**METROPOLITAN COAL PROJECT
RESPONSES TO SUBMISSIONS
PART C**

**METROPOLITAN COAL PROJECT
RESPONSES TO
PLANNING ASSESSMENT COMMISSION QUERIES**

24 February 2009

PLANNING ASSESSMENT COMMISSION
METROPOLITAN COAL PROJECT INFORMATION REQUEST

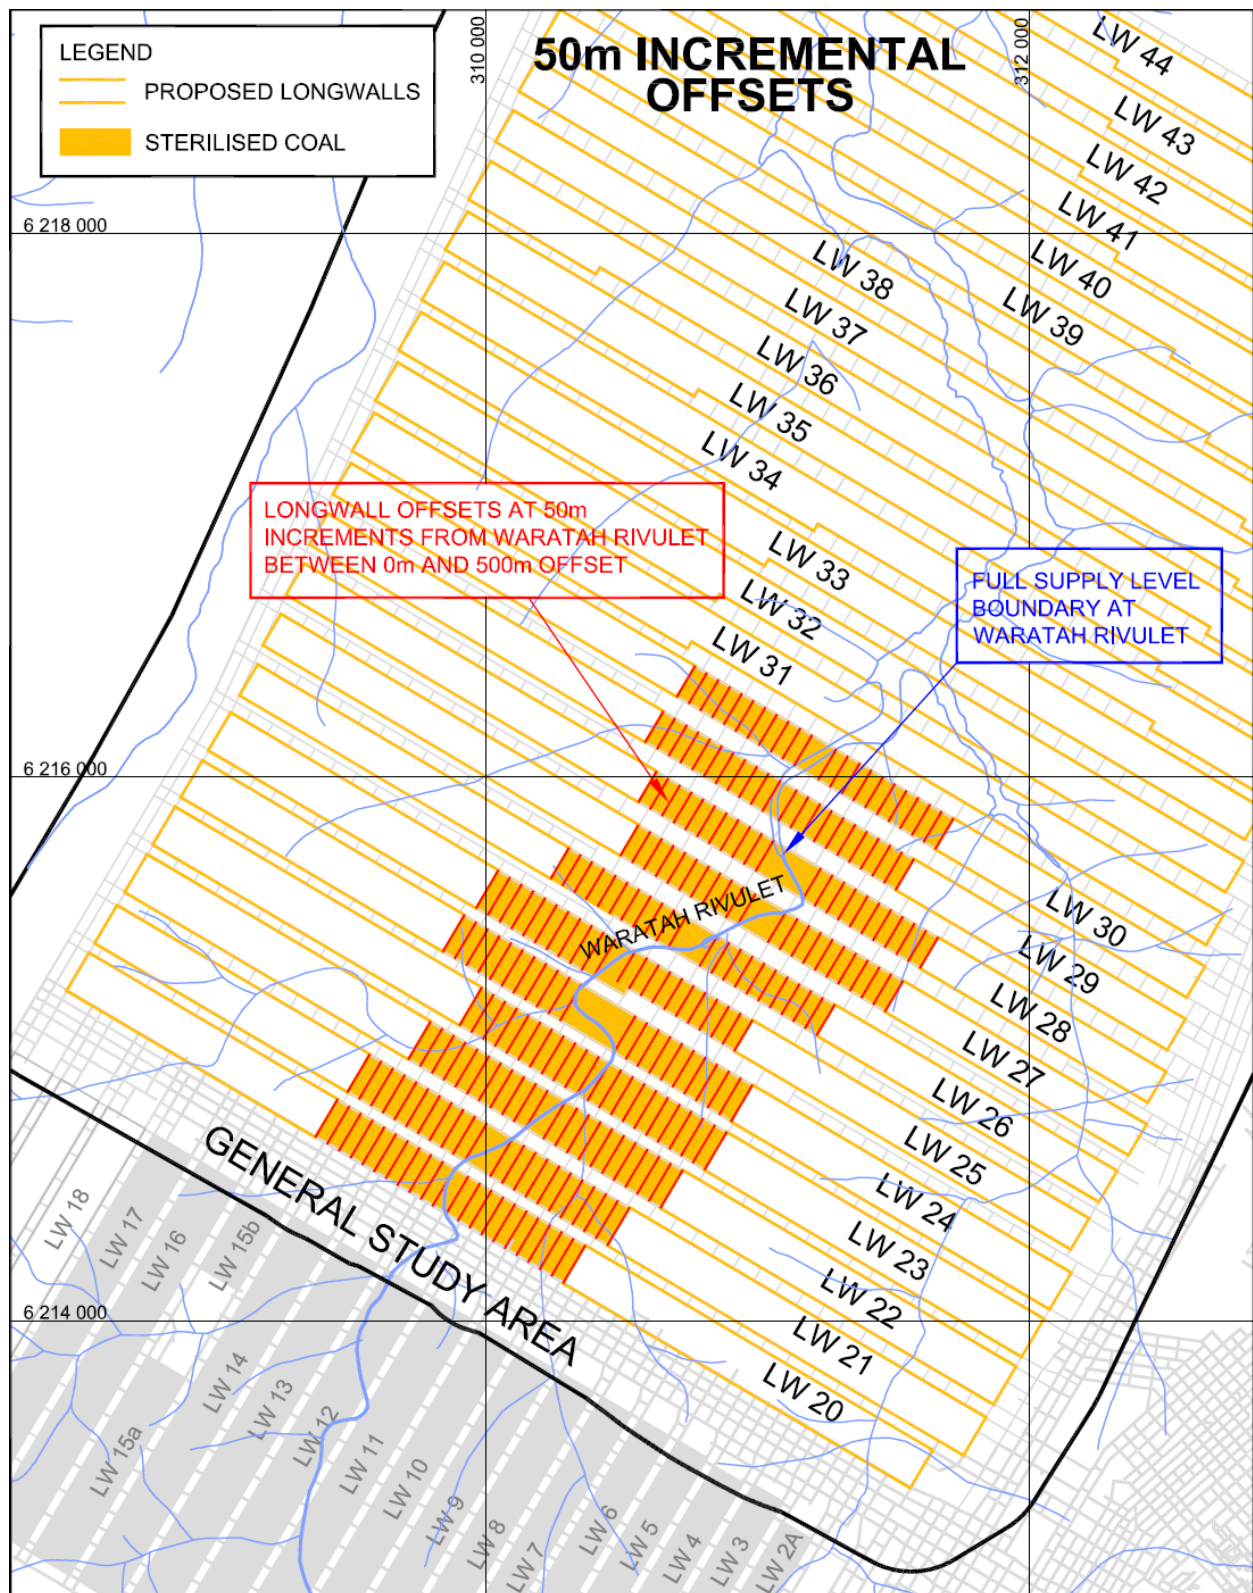
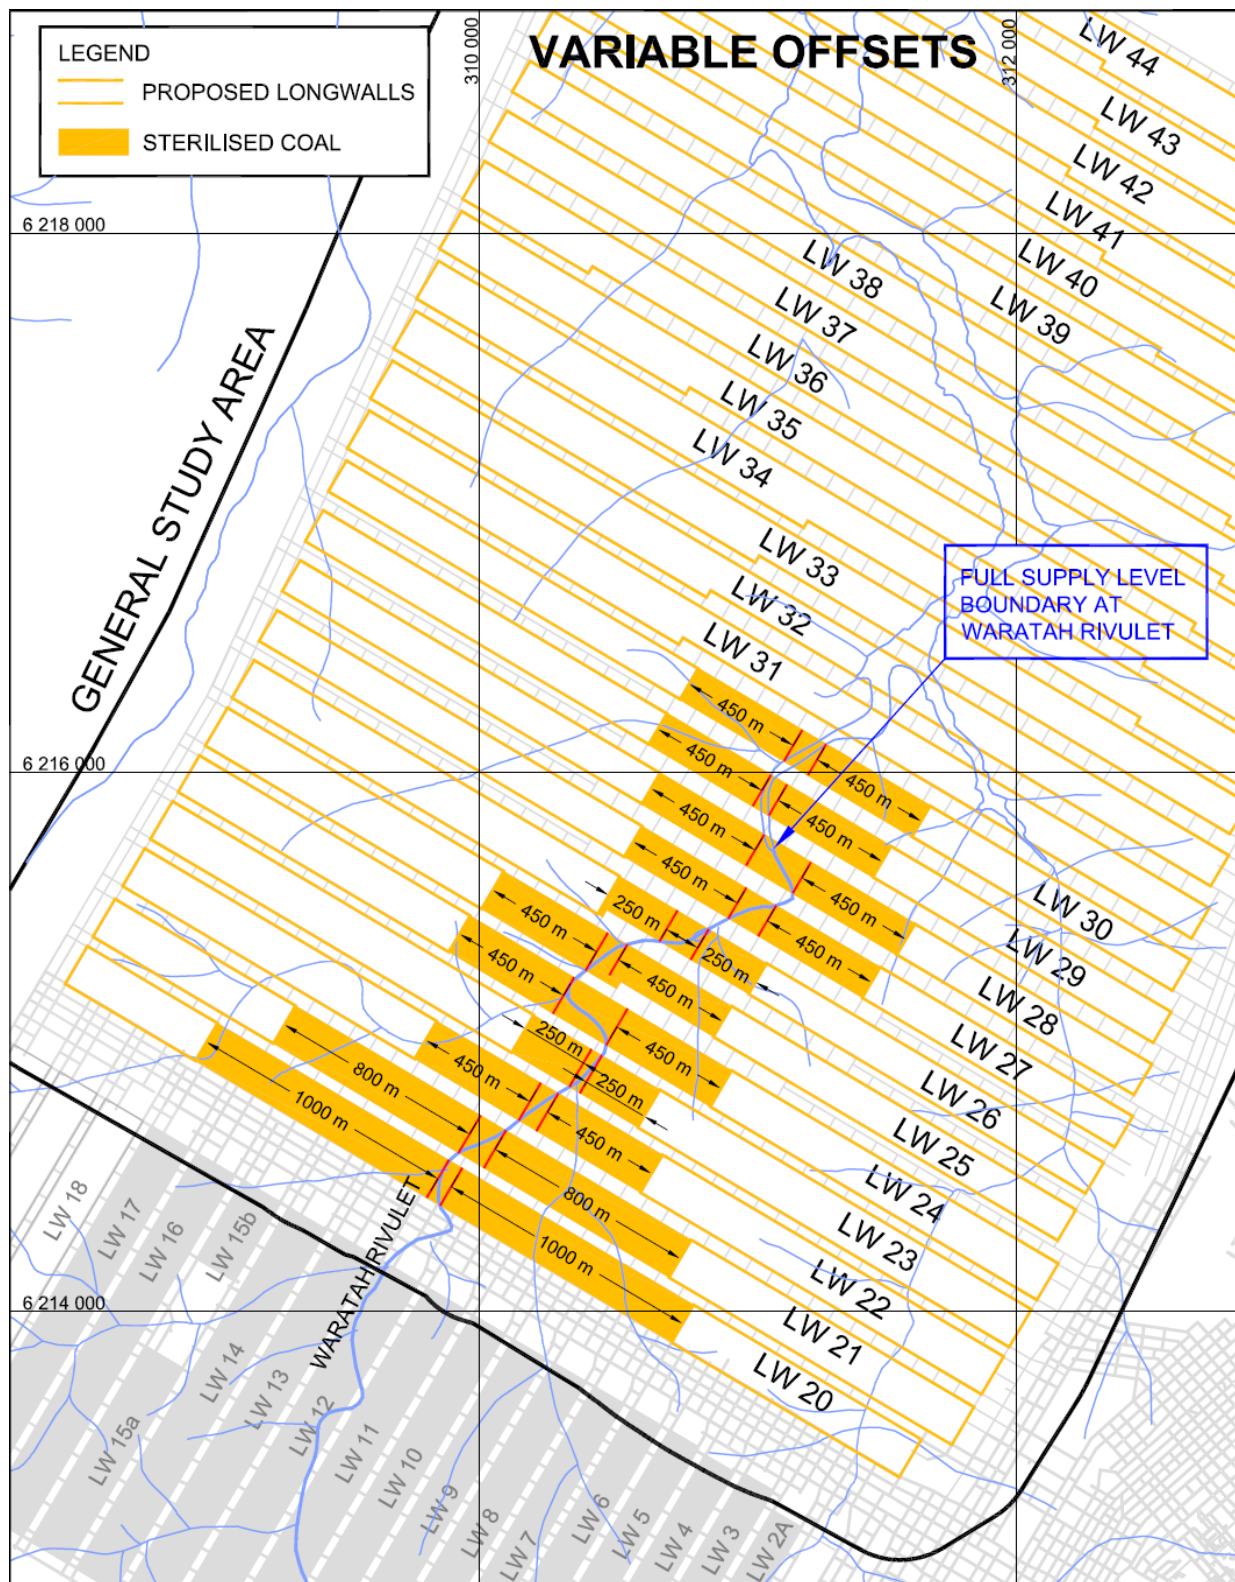
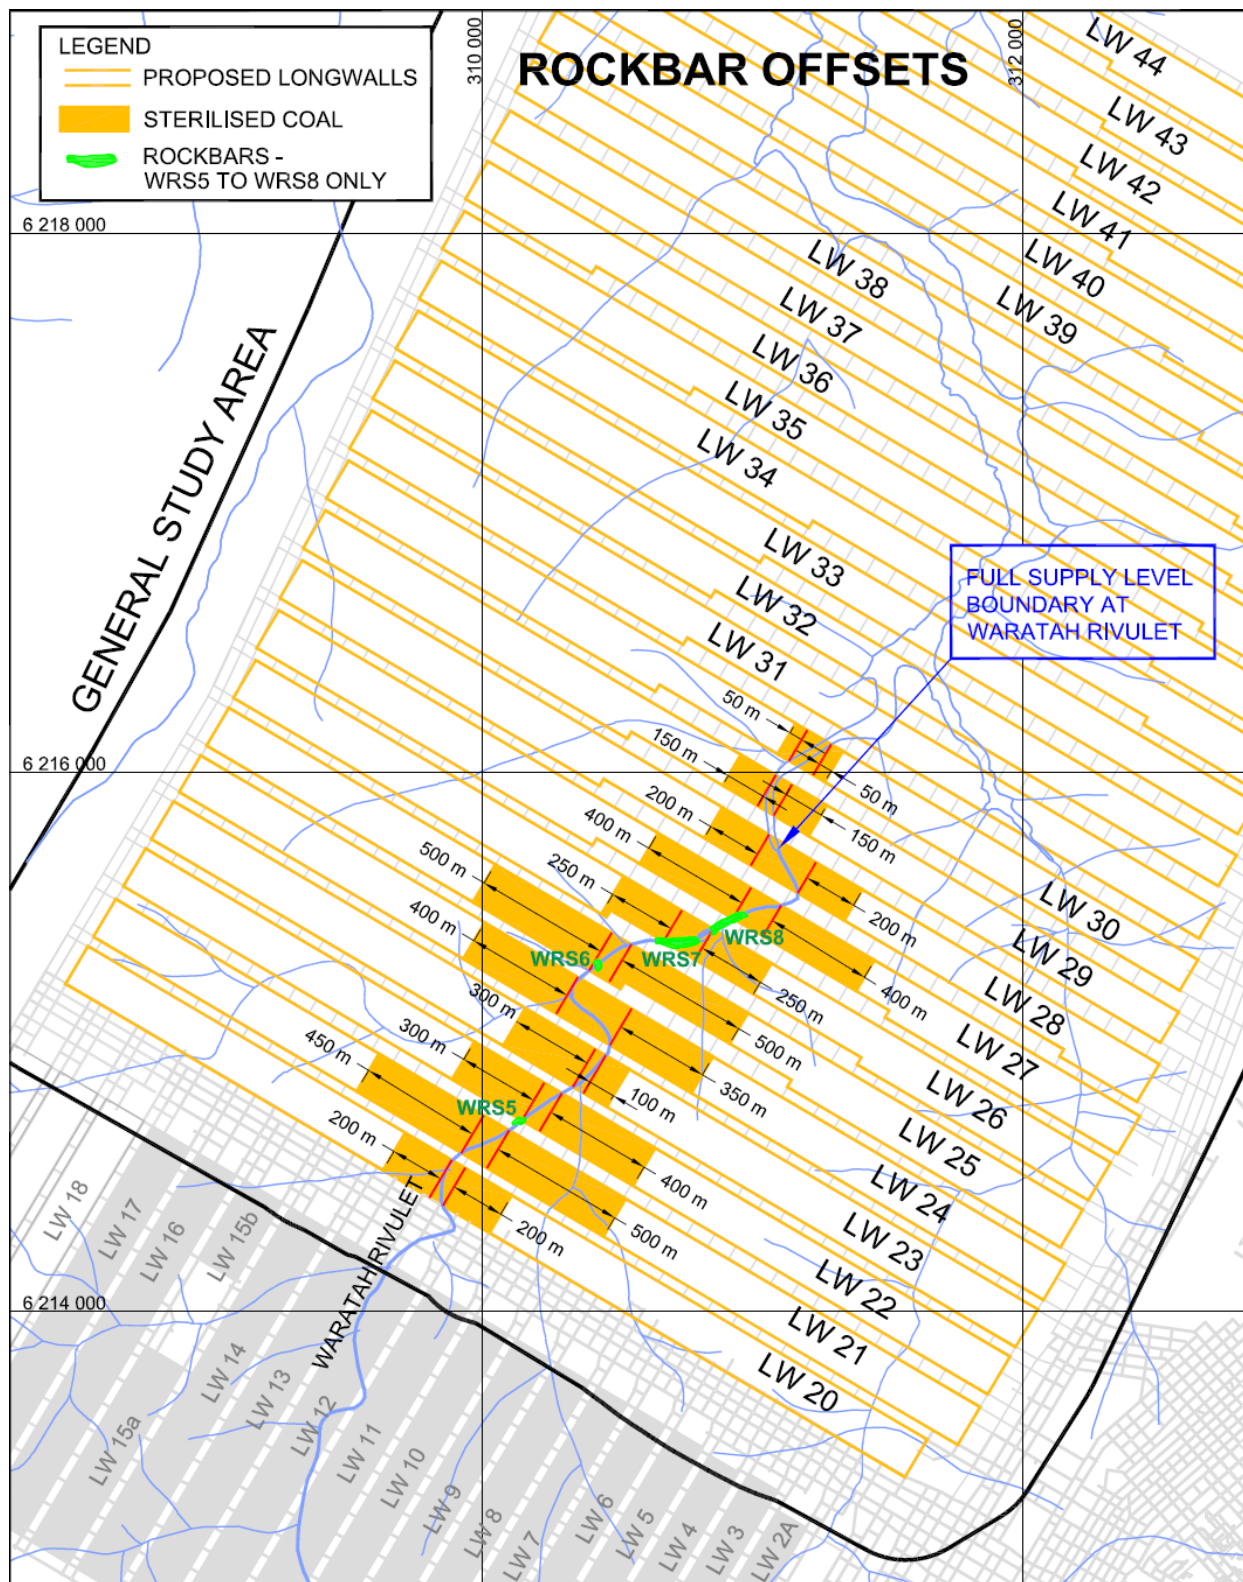
4.	The assessed costs of a 500 m setback on each side of Waratah Rivulet over longwalls 20-29 is reported in the EA and Appendix M as \$114 M. What is the cost, calculated on the same basis, of the setbacks shown in Figures 5.4[i] and 5.4[ii] in Appendix A?	Page 7

List of PAC Questions		Response Page Number
Proposed Mine Layout (Continued)		
11.	As an alternative to barrier pillars under each longwall beneath the Waratah Rivulet, has the mine considered taking all of every 3rd longwall beneath the stream. What are the potential costs and benefits of such an approach, cf the layouts shown in Figs 5.4[i] and 5.4[ii] in Appendix A?	Page 31

Further analysis of the relative costs and benefits of the setback scenarios shown on Figures 5.4, 5.4(i) and 5.4(ii) of Appendix A (herein described as Scenario Figure 5.4, Scenario Figure 5.4(i) and Scenario Figure 5.4(ii)) has been conducted.

Component	Scenario Figure 5.4	Scenario Figure 5.4(i)	Scenario Figure 5.4(ii)
Incremental Net Production Benefit/Cost	-\$147M	-\$152M	-\$95M
Incremental Estimated Environmental Benefit (due to reduced environmental impacts)	+\$111M	+\$111M	+\$58M
Incremental Estimated Social Costs (due to reduced mine life)	-\$106M	-\$108M	-\$63M
Incremental Net Community Benefit/Cost	-\$142M	-\$149M	-\$100M

This analysis indicates that with the inclusion of the social community values estimated via the Choice Modelling Study – setbacks in Scenario Figure 5.4, Scenario Figure 5.4(i) and Scenario Figure 5.4(ii) are not economically efficient and all result in a significant net cost to society.

Scenario	Figure 5.4	Figure 5.4 Every Third Panel Under	Figure 5.4(i)	Figure 5.4(i) Every Third Panel Under	Figure 5.4(ii)	Figure 5.4(ii) Every Third Panel Under
Net Production Cost/Benefit	-\$147M	-\$148M	-\$152M	-\$148M	-\$95M	-\$92M
Net Community Cost/benefit	-\$142M	-\$143M	-\$149M	-\$145M	-\$100M	-\$96M

The analysis indicates that with the inclusion of the social community values estimated via the Choice Modelling Study – setbacks in Scenario Figure 5.4, Scenario Figure 5.4(i) and Scenario Figure 5.4(ii) remain economically inefficient with or without having every third longwall under the stream and all result in a significant net cost to society.

Figure MSEC-7 Comparison of Predicted Incremental Systematic Subsidence, Tilt and Strain with Observations along the D Line

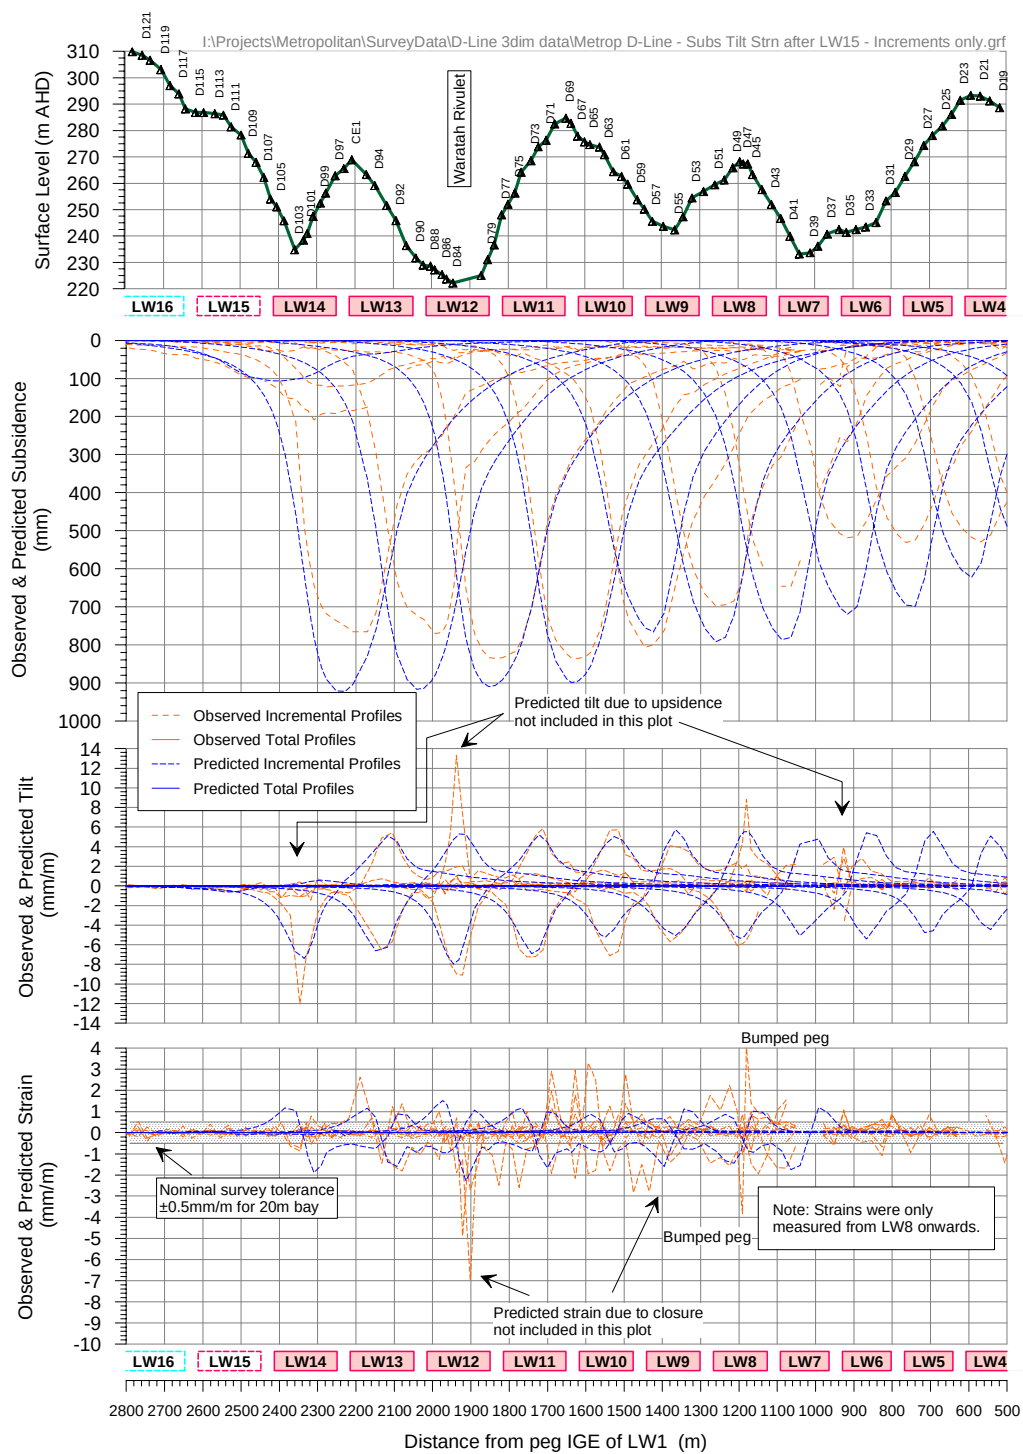
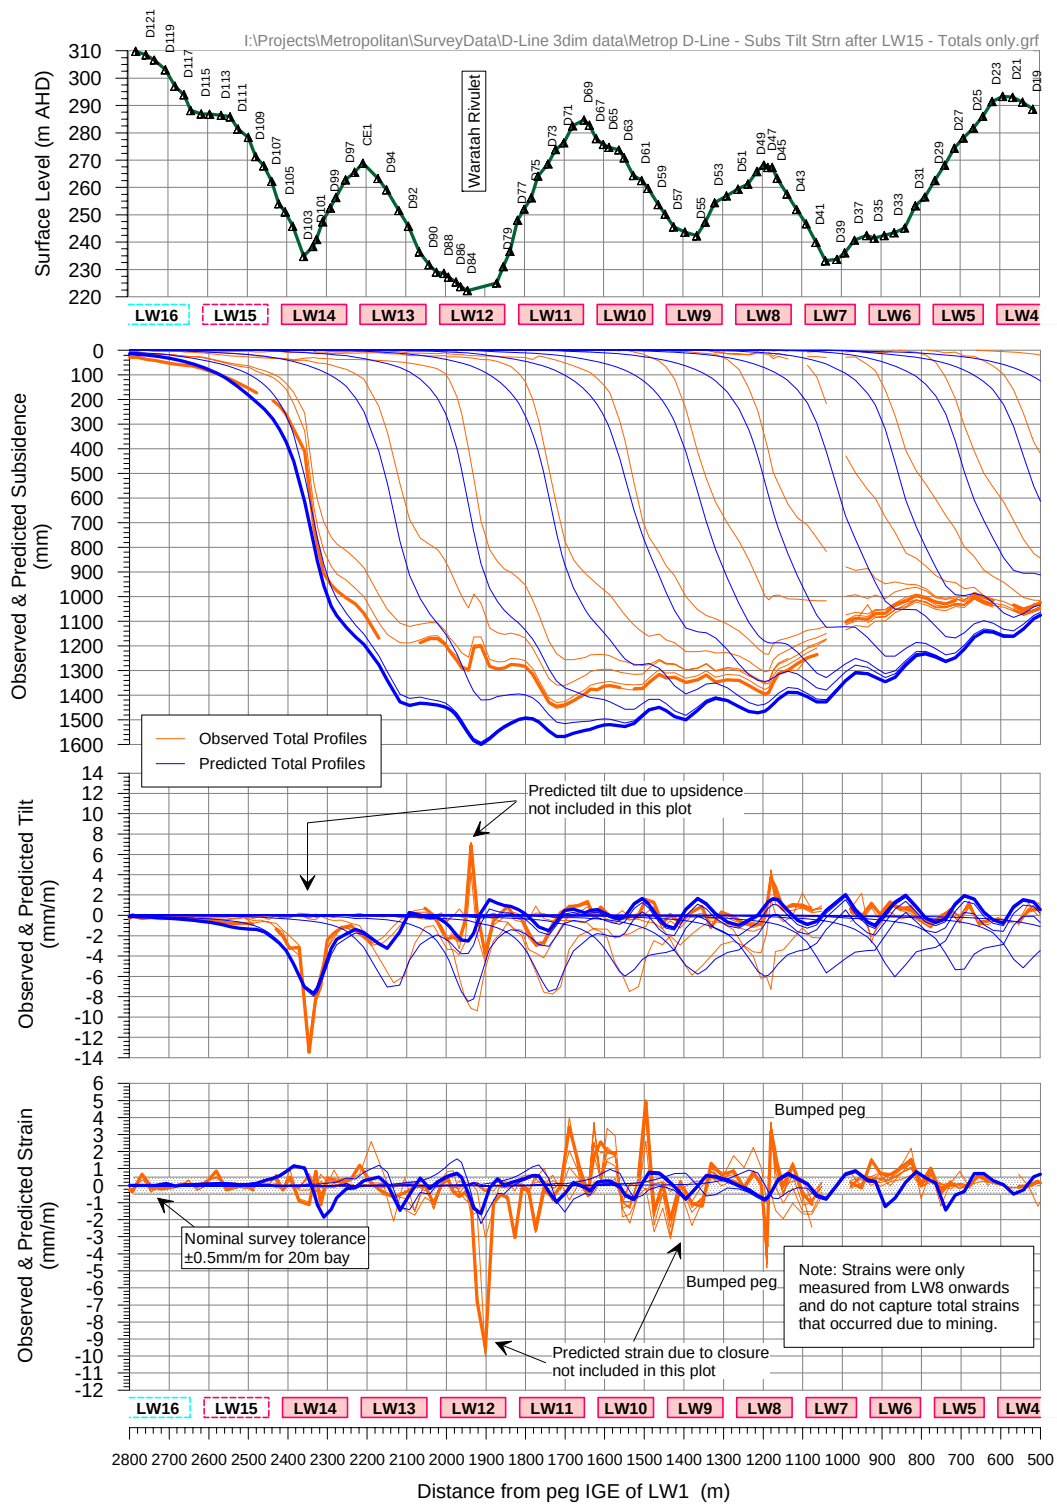
- 18. Figs 3.12 and 3.13 in Appendix A show predicted and observed subsidence and strain profiles along the D survey line, but no data for predicted and observed tilt. Please provide this data. What accuracy is being assigned to predictions of tilt?**

Figs 3.12 and 3.13 in Appendix A (Report No. MSEC285) are reproduced below as Figure MSEC-7 and Figure MSEC-8 respectively with added data for predicted and observed tilt.

The systematic tilts can be predicted to the same level of accuracy as subsidence, but the measured curvatures and strains can vary considerably from the predicted systematic values for the following reasons:-
